re: Grading and Site Servicing Plans Review Proposed Church 3555 Borrisokane Road, Ottawa, Ontario to: Fotenn Consultants Inc. – Mr. Nico Church – church@fotenn.com

- to: Fotenn Consultants Inc. Mr. Thomas Freeman freeman@fotenn.com
- date: February 22, 2024
- file: PG6842-MEMO.02 Revision 1

-						
1		Ē		NEE	RIN	١G
	DESIGNED BY	NW/MWD	HORIZ SCALE	1: 300	PROJECT #	22099
	DRAWN BY	JM	VERT SCALE	N/A	DRAWING #	SG-1
	CHECKED BY	MWD	DATE	JUNE 2023	REVISION #	2

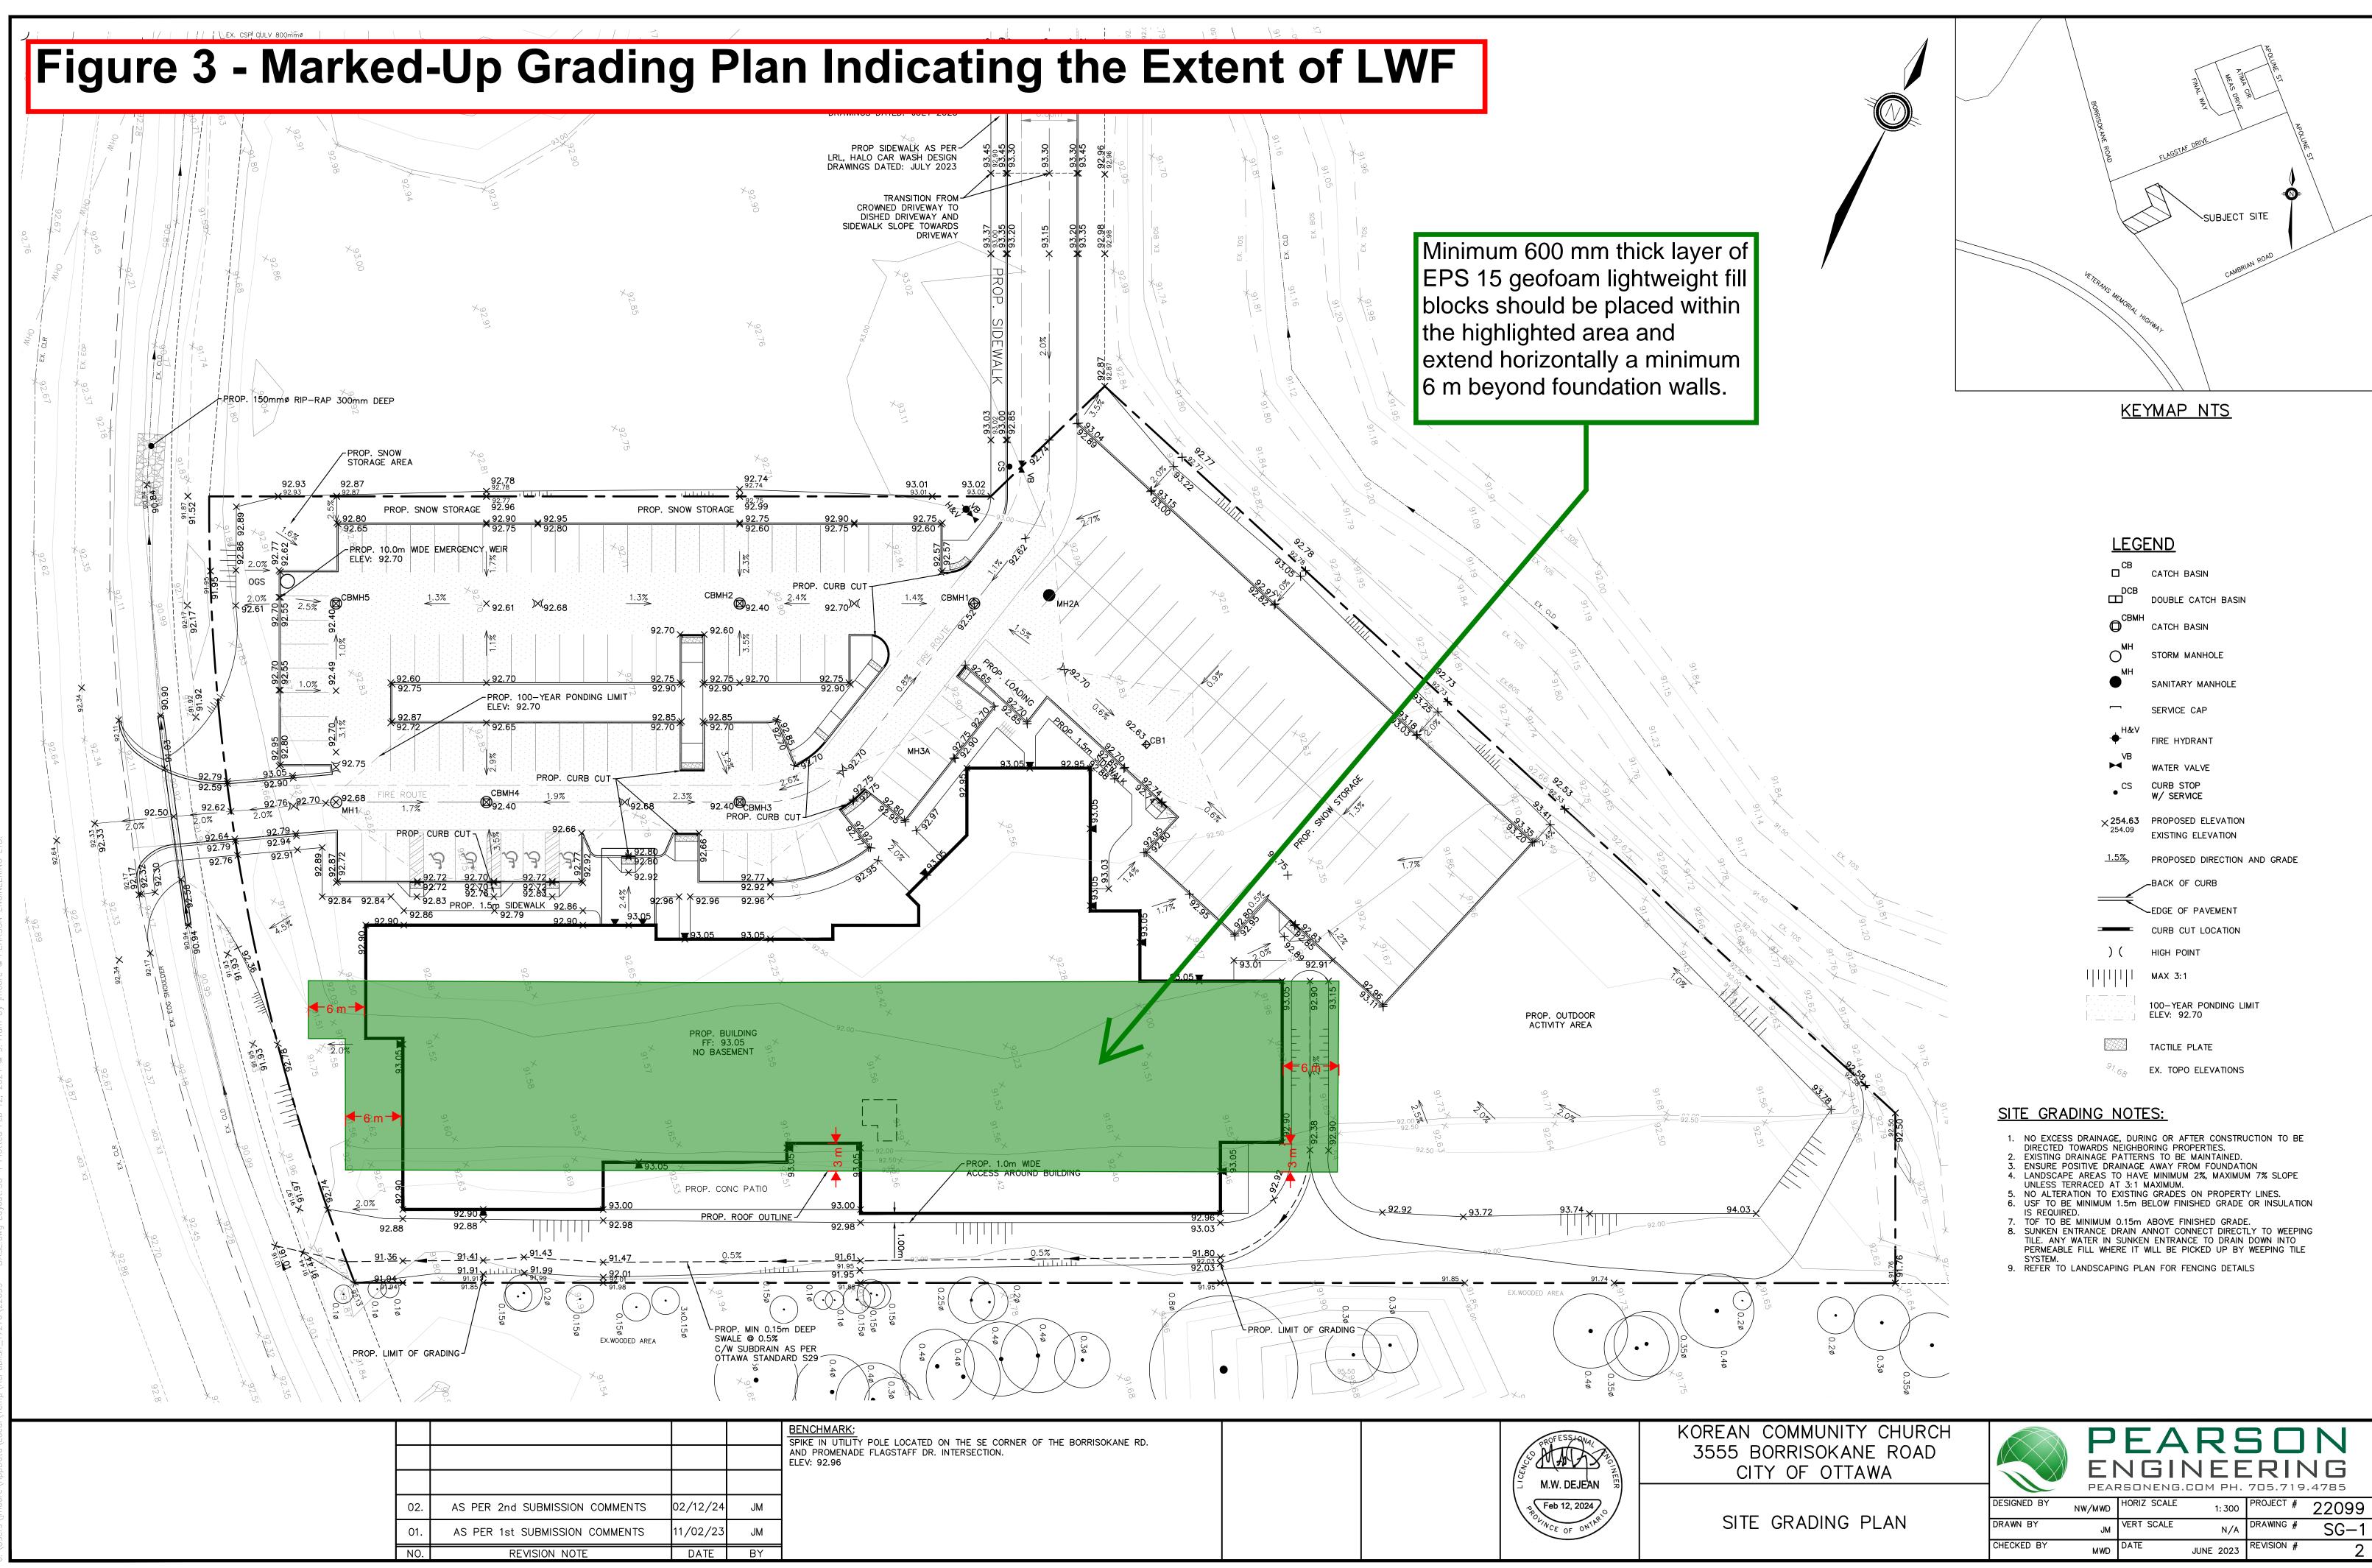
Based on our review of the above-noted drawing, the proposed grading was found to be within the permissible grade raise of 1.5 m for the proposed parking areas, access roads, and landscaping areas. However, based on the finished floor elevations and proposed grade raise around the building, lightweight fill (LWF) should be placed below the middle portion of the proposed building footprint with a minimum thickness of 600 mm as shown in Figure 2 attached to the current memorandum. In addition, The LWF shall extend 6m beyond the face of the building as presented area in Figure 2.

Reference should be made to Figure 1 - EPS Block Installation Recommendations and to Figure 3 - Marked-Up Grading Plan Indicating the Extent of LWF. It shall be noted that the LWF shall not extend vertically below the USF. The LWF should consist of EPS (expanded polystyrene) geofoam blocks, which allow for raising the grade without adding a significant load to the underlying soils. For this application, EPS type 15 should be used.

SITE SERVICING PLAN

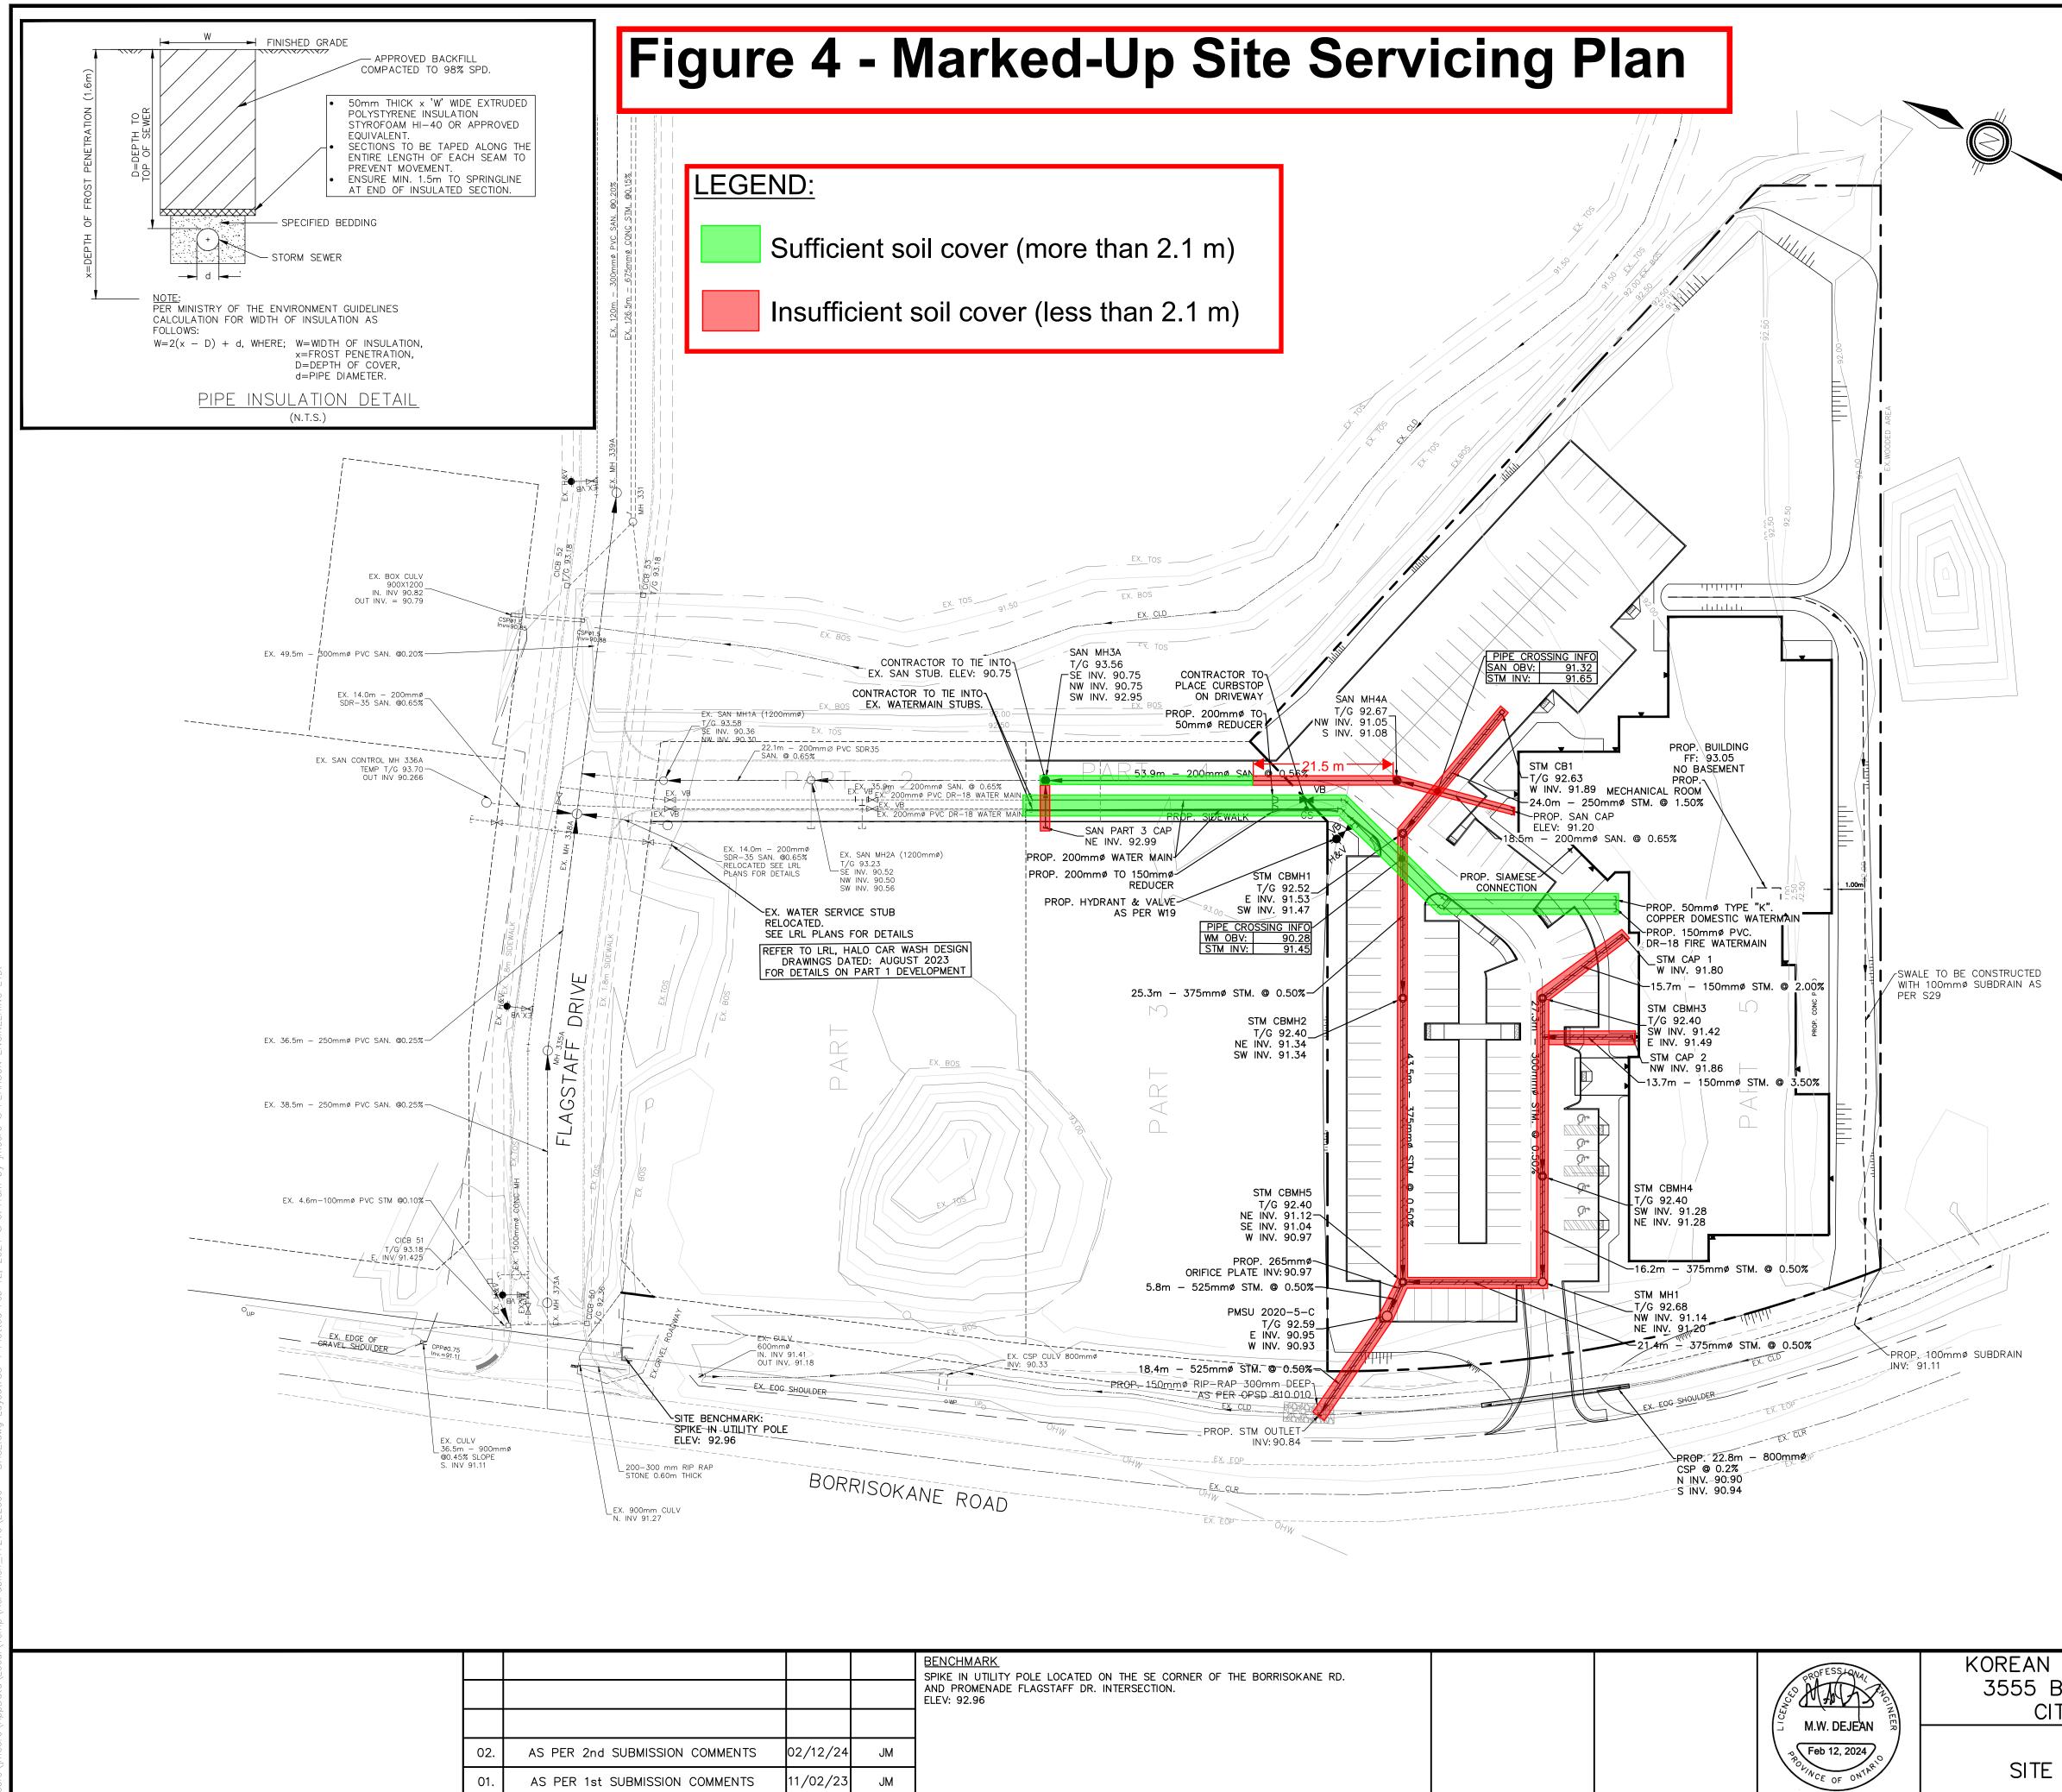
Further, it should be noted that all watermain pipes have been provided with sufficient soil cover at the subject site for the frost protection. However, insufficient frost protection has been provided for the majority of the proposed storm and sanitary sewer pipes throughout the subject site. The proposed storm and sanitary sewer pipes are located within the frost zone, approximately 2.1 m below the finished grade. In the following section, frost protection of the site servicing is recommended where insufficient frost cover has been provided. Reference should be made to Figure 4 - Marked-Up Site Servicing Plan indicating where insufficient frost cover has been provided, attached to the current memorandum.

Any portion of the services installed at a depth of 2.1 m below finished grade or deeper is considered to have sufficient soil cover for frost protection. Where insufficient soil cover is present above the invert of storm and sanitary sewer pipes, the following frost protection criteria should be followed:

All rigid insulation should consist of either Dow Chemical High-Load 40 (HI-40), Styro Rail SR.P400, or equivalent approved by Paterson. The placement of all insulation within the service trenches must be reviewed and approved by Paterson personnel at the time of construction. Reference should be made to Figure 2 - Typical Frost Insulation Detail, attached to this memorandum.
